Addendum No. 1

Re: Part B - James M. Seals, JR. Park – Athletic Restroom/ Concession and Field Improvements
504 Texas Street, Mobile, AL 36603
Project No. PR-041-20
Part C - Hackmeyer Park – Improvements Phase 2
3810 Conway Drive South, Mobile, AL 36608
Project No. PR-034-21

Date: November 14, 2022

1 ROOF PLAN

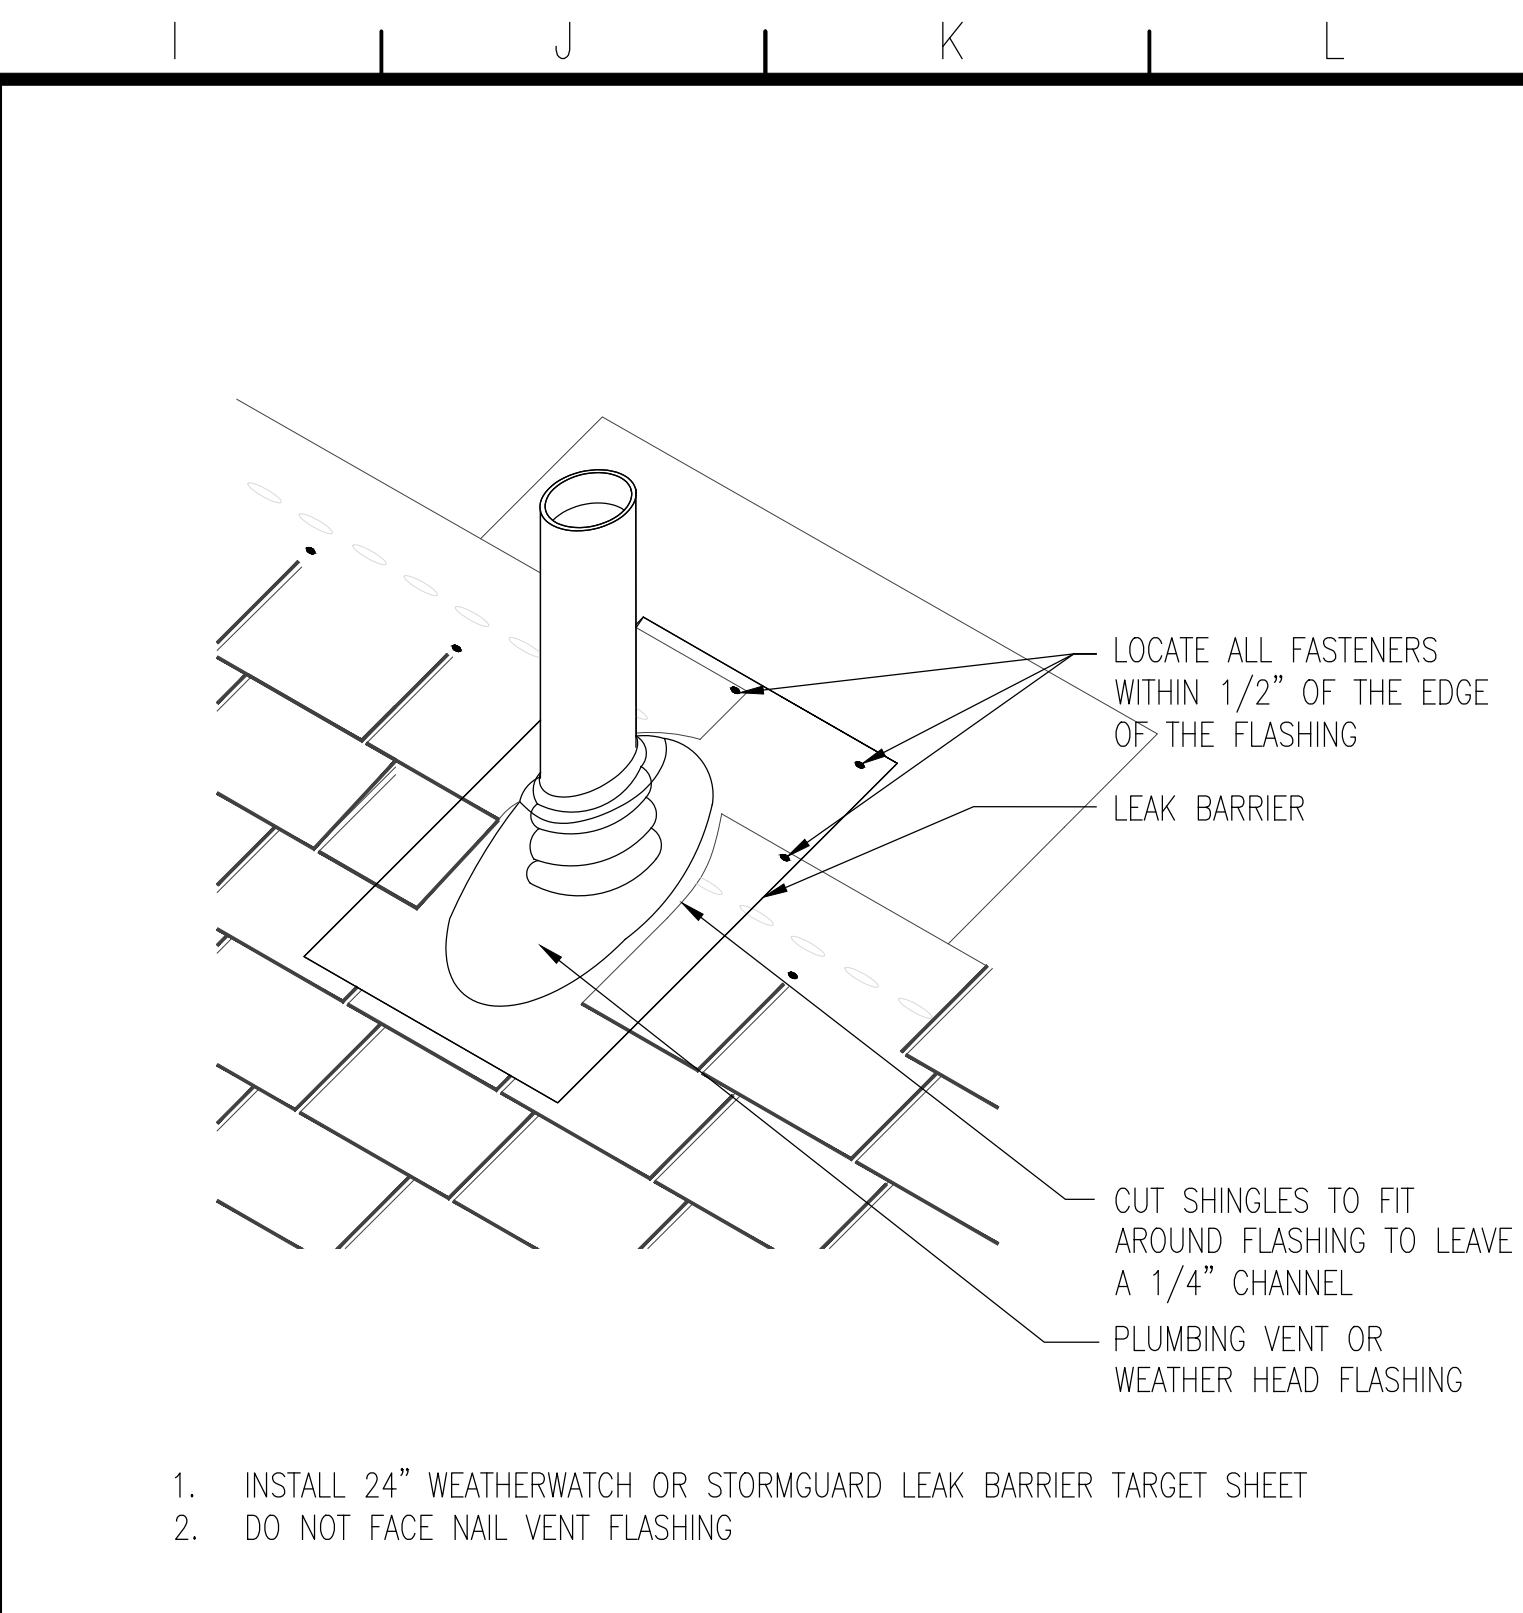
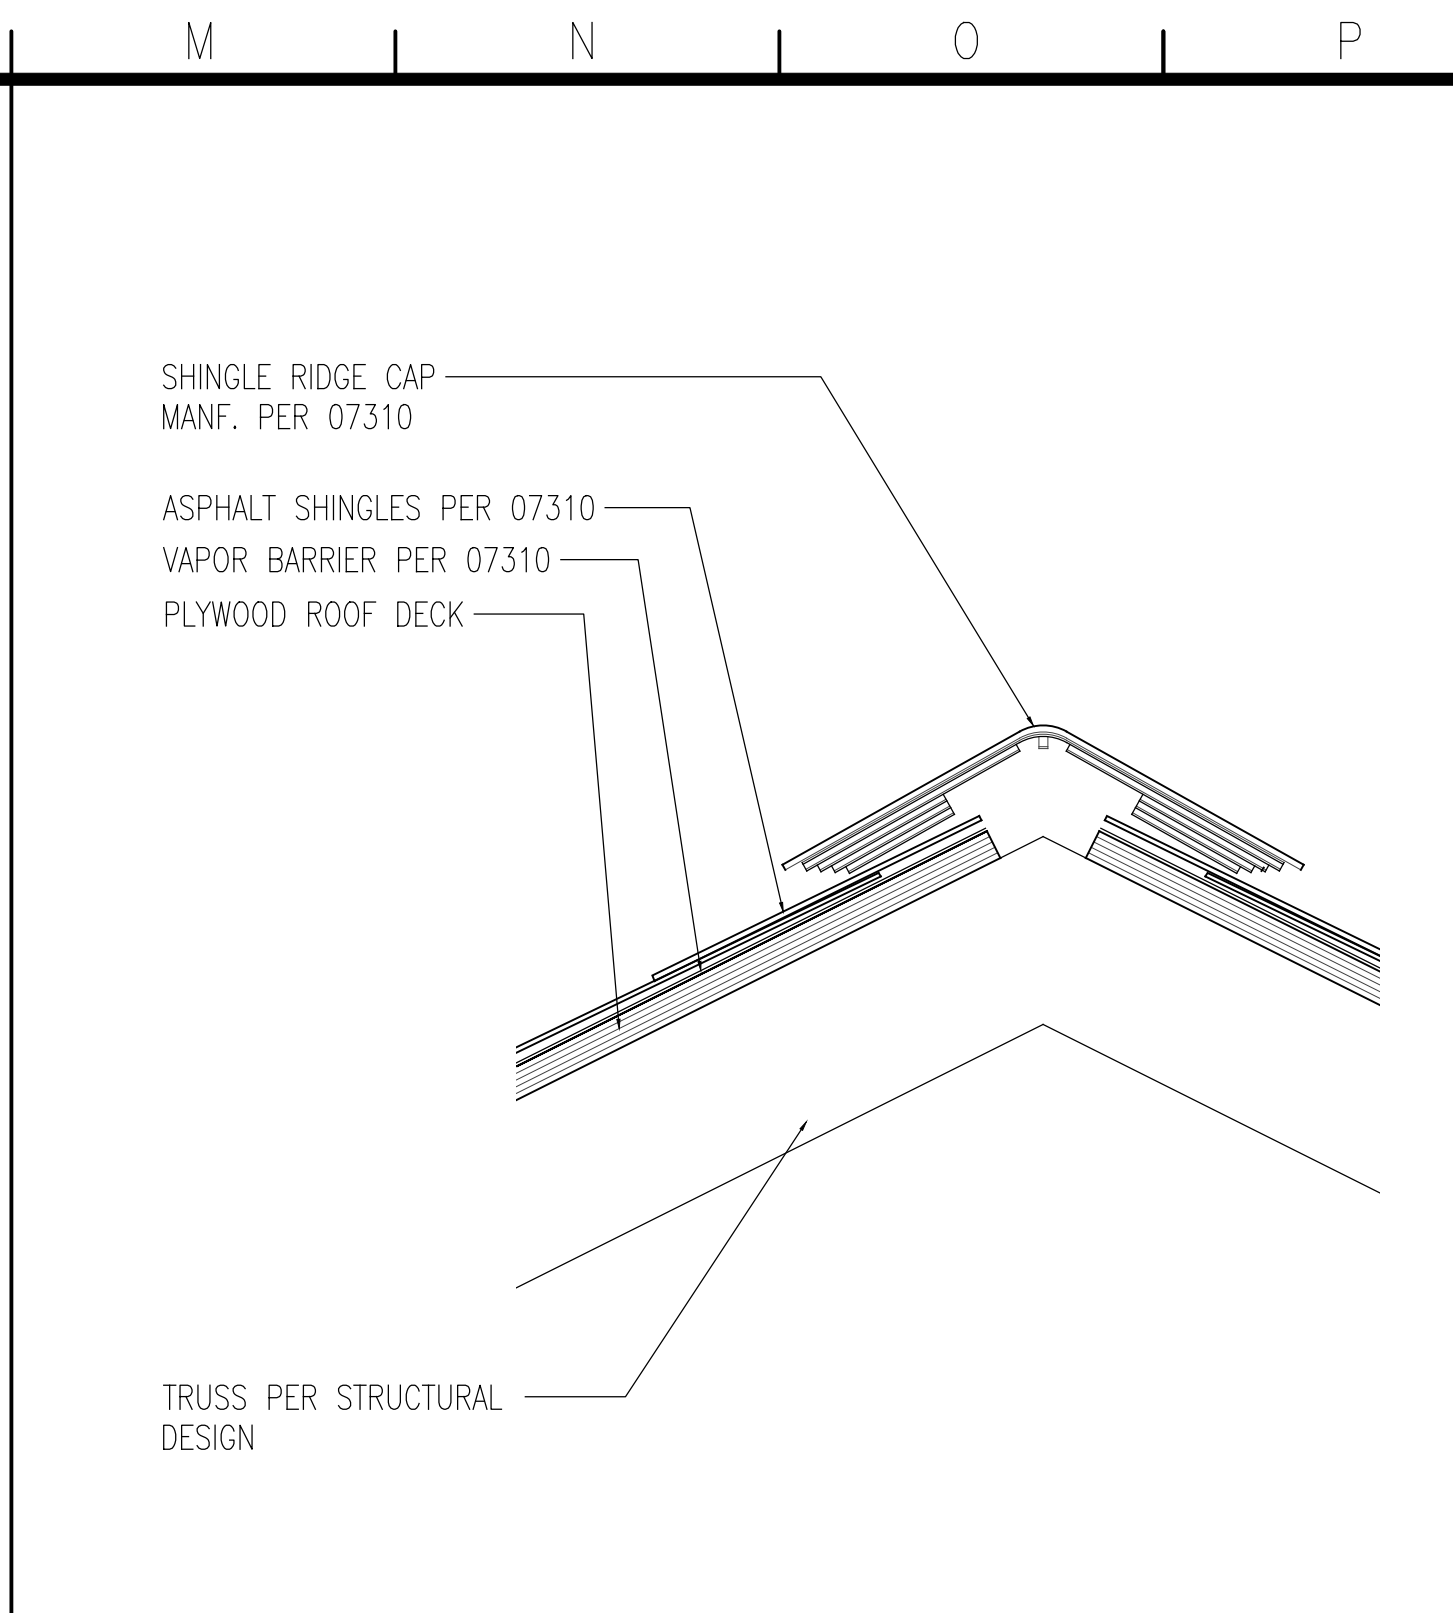
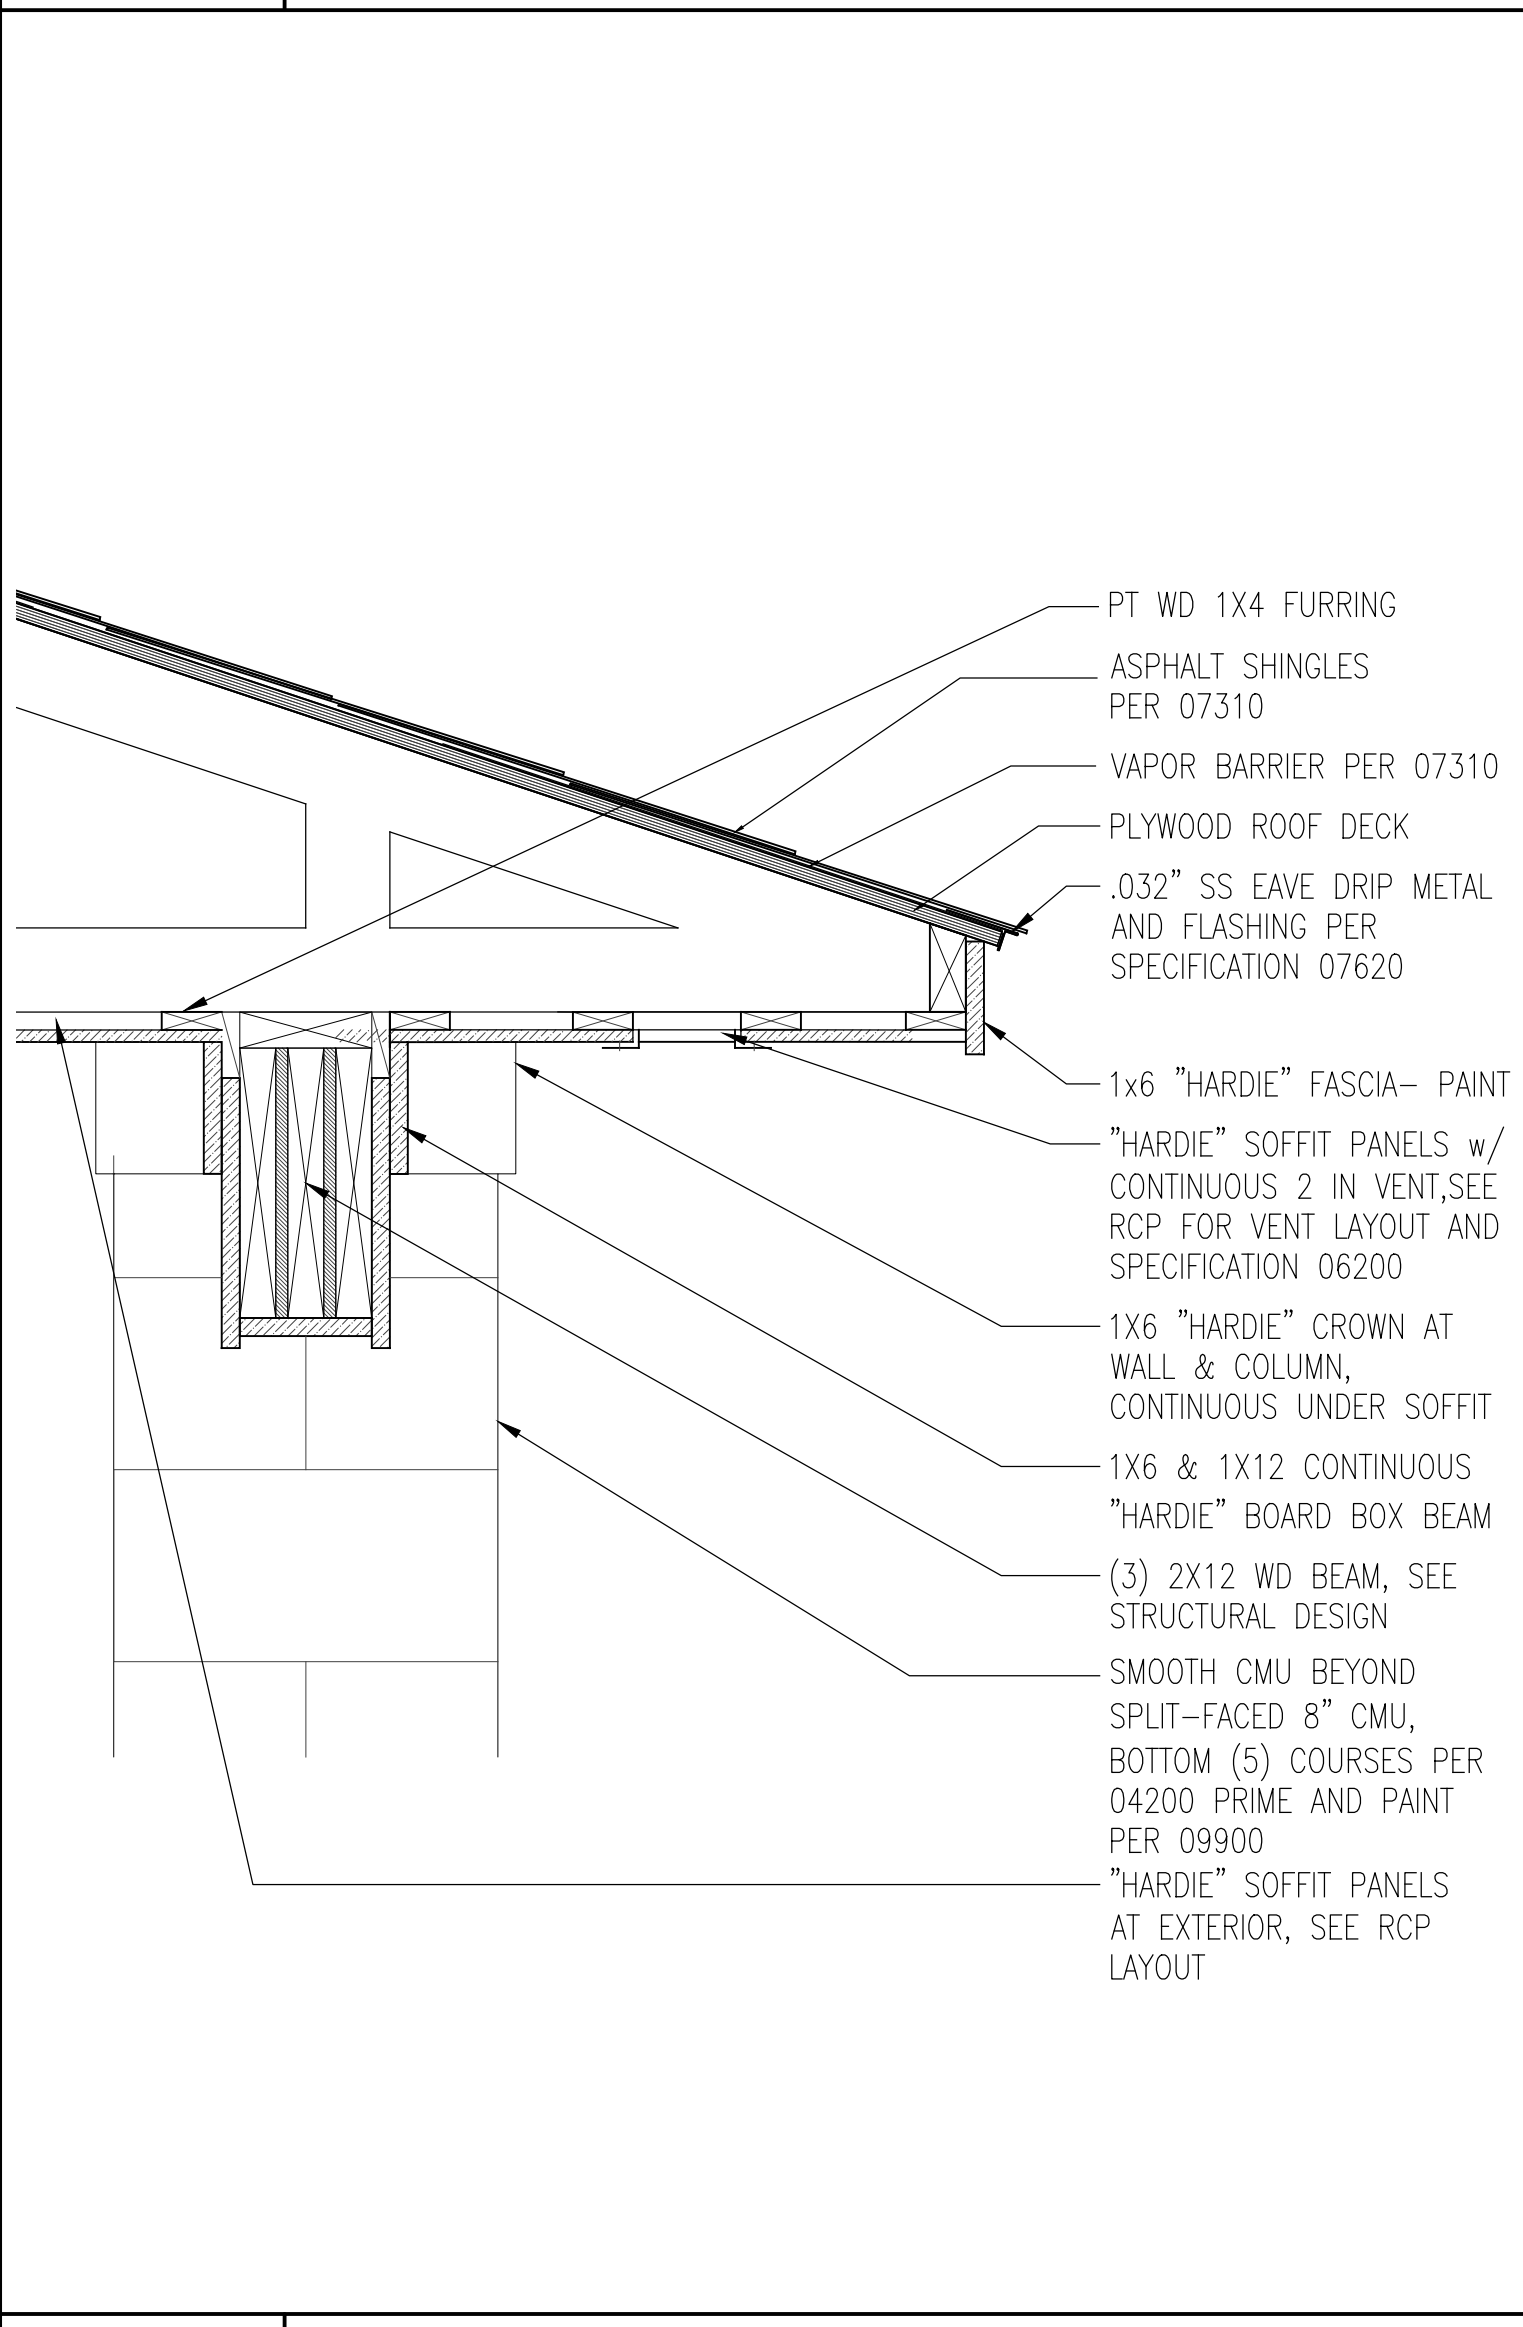
Item 15: Sheet A1.3 Building – Roof Plan

Replace this sheet dated 11.02.22 with the attached revised sheet of same title A1.3, dated November 07, 2022 and labeled Revision 01 (Addendum No. 1). Substantial changes include the following:

- Update detail section marks on roof plan.
